SUBJECT: ISSUANCE OF AMENDMENT NO. 173 TO FACILITY OPERATING LICENSE DPR-57
AND AMENDMENT NO. 113 TO FACILITY OPERATING LICENSE NPF-5 - EDWIN I.
HATCH NUCLEAR PLANT, UNITS 1 AND 2 (TACs 77822/77823)

AMENDMENT NO.173TO FACILITY OPERATING LICENSE DPR-57 - Edwin I. Hatch
Nuclear Plant, Unit 1

AMENDMENT NO.113TO FACILITY OPERATING LICENSE NPF-5 - Edwin I. Hatch
Nuclear Plant, Unit 2

SAFETY EVALUATION BY THE OFFICE OF NUCLEAR REACTOR REGULATION
RELATED TO AMENDMENT NO. 173 TO FACILITY OPERATING LICENSE DPR-57
AND AMENDMENT NO. 113 TO FACILITY OPERATING LICENSE NPF-5

FIGURE 2.1-1
REACTOR VESSEL WATER LEVEL

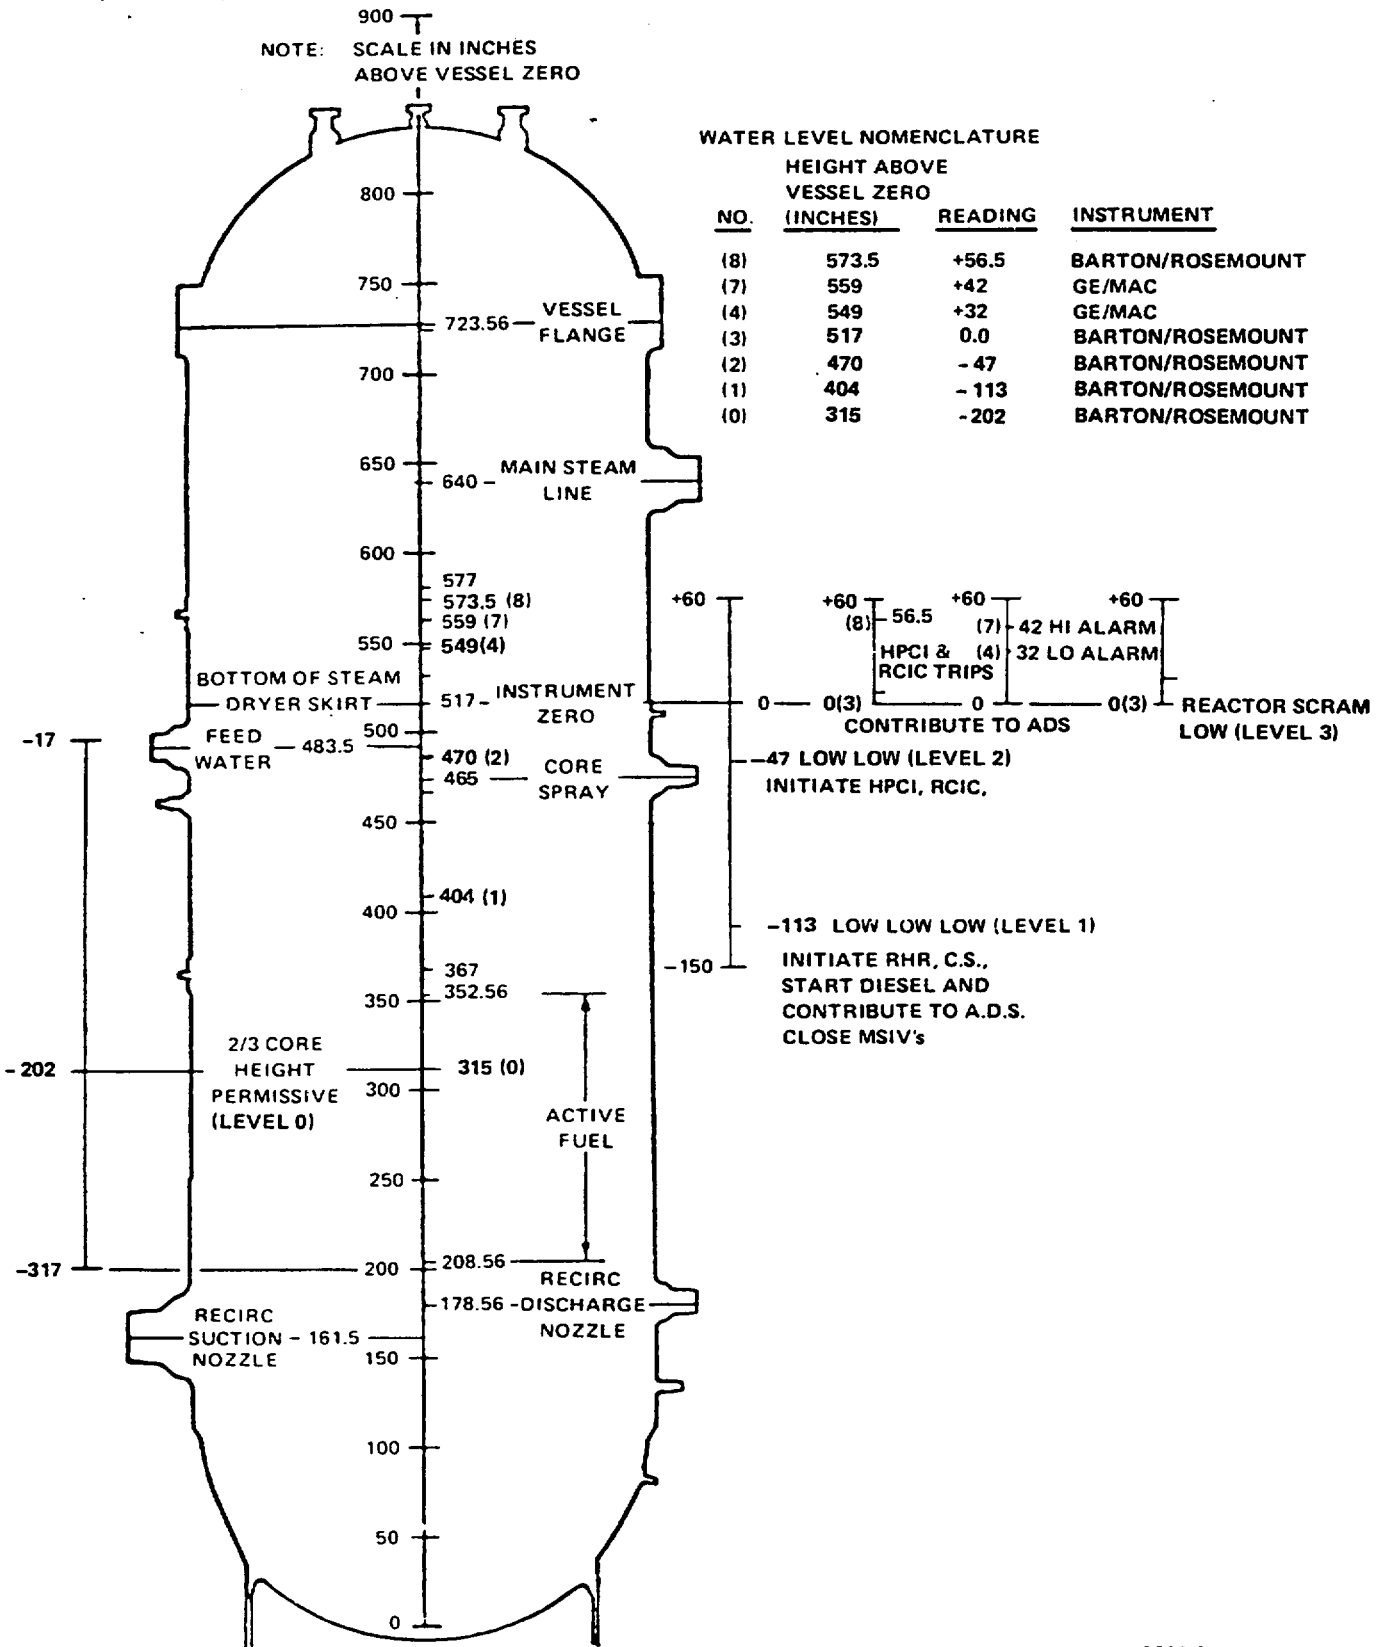
- 2.1.A.2. Reactor Vessel Water Low Level Scram Trip Setting (Level 3)

Reactor vessel water low level scram trip setting (Level 3) shall be ≥ 0.0 inches (narrow range scale).

The trip setting for low level scram is above the bottom of the separator skirt, Figure 2.1-1. This level is approximately 14 feet above the top of the active fuel. This level has been used in transient analyses dealing with coolant inventory decrease. The results reported in FSAR Section 14.3 show that a scram at this level adequately protects the fuel and the pressure barrier. The designated scram trip setting is at least 22 inches below the bottom of the normal operating range and is thus adequate to avoid spurious scrams.

BASES FIGURE B 3/4 3-1
REACTOR VESSEL WATER LEVEL

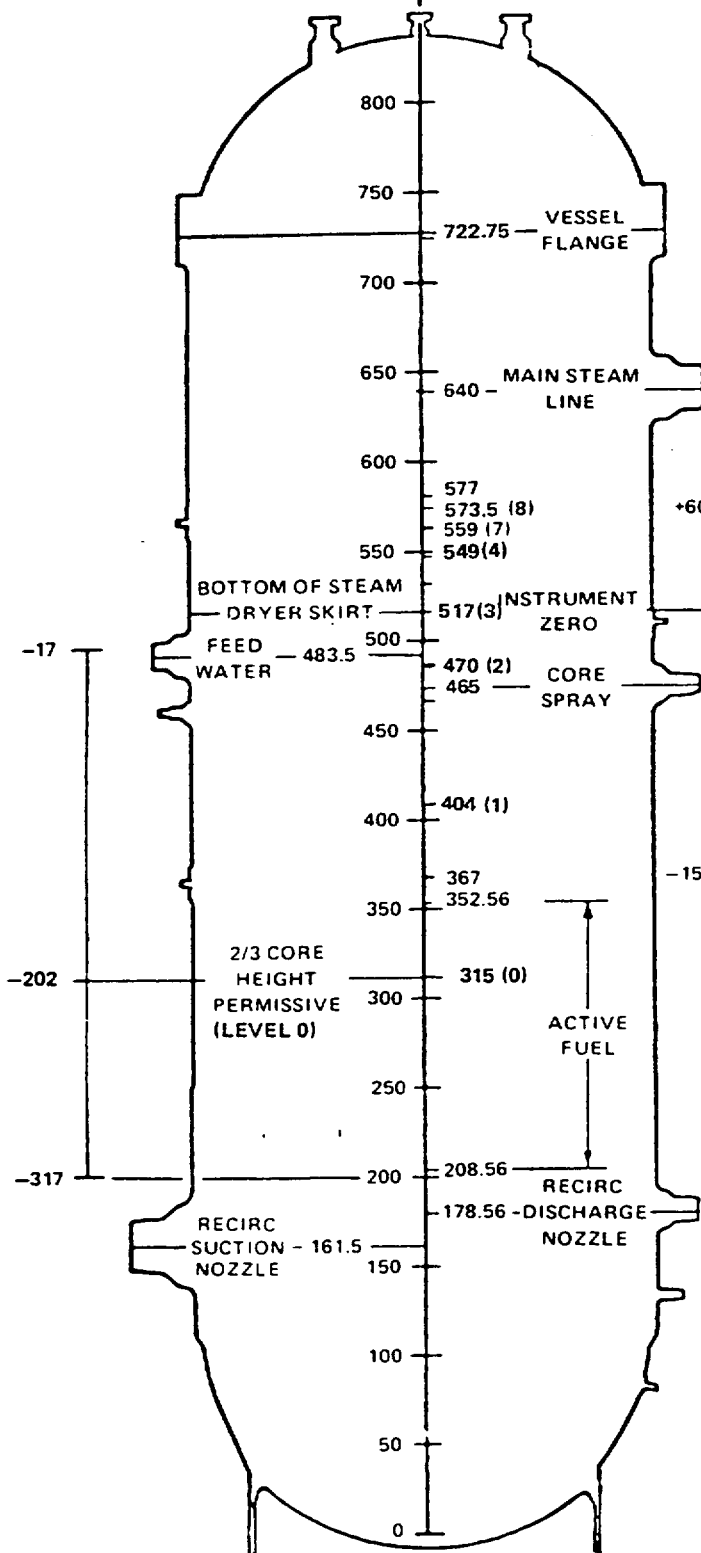
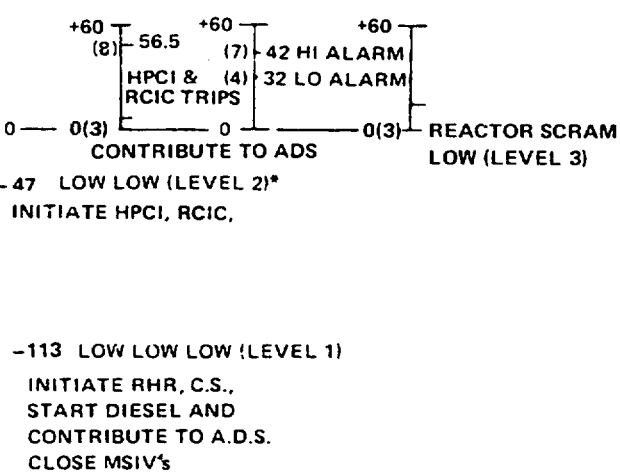
4. Reactor Vessel Water Level - Low (Level 3) (2B21-N680 A,B,C,D)	\geq 0 inches above instrument zero*	\geq 0 inches above instrument zero*
5. Main Steam Line Isolation Valve - Closure (NA)	\leq 10% closed	\leq 10% closed

<u>TRIP FUNCTION</u>	<u>TRIP SETPOINT</u>	<u>ALLOWABLE VALUE</u>
1. <u>PRIMARY CONTAINMENT ISOLATION</u>		
a. Reactor Vessel Water Level		
1. Low (Level 3)	≥ 0 inches*	≥ 0 inches*

e. Reactor Vessel Water Level - Low (Level 3)	≥ 0 inches*	≥ 0 inches*
f. Core Spray Pump Discharge Pressure - High	≥ 137 psig	≥ 137 psig
g. RHR (LPCI MODE) Pump Discharge Pressure - High	≥ 112 psig	≥ 112 psig

NO.	HEIGHT ABOVE VESSEL ZERO (INCHES)	READING	INSTRUMENT
(8)	573.5	+56.5	BARTON/ROSEMOUNT
(7)	559	+42	GE/MAC
(4)	549	+32	GE/MAC
(3)	517	0.0	BARTON/ROSEMOUNT
(2)	470	- 47	BARTON/ROSEMOUNT
(1)	404	- 113	BARTON/ROSEMOUNT
(0)	315	-202	BARTON/ROSEMOUNT
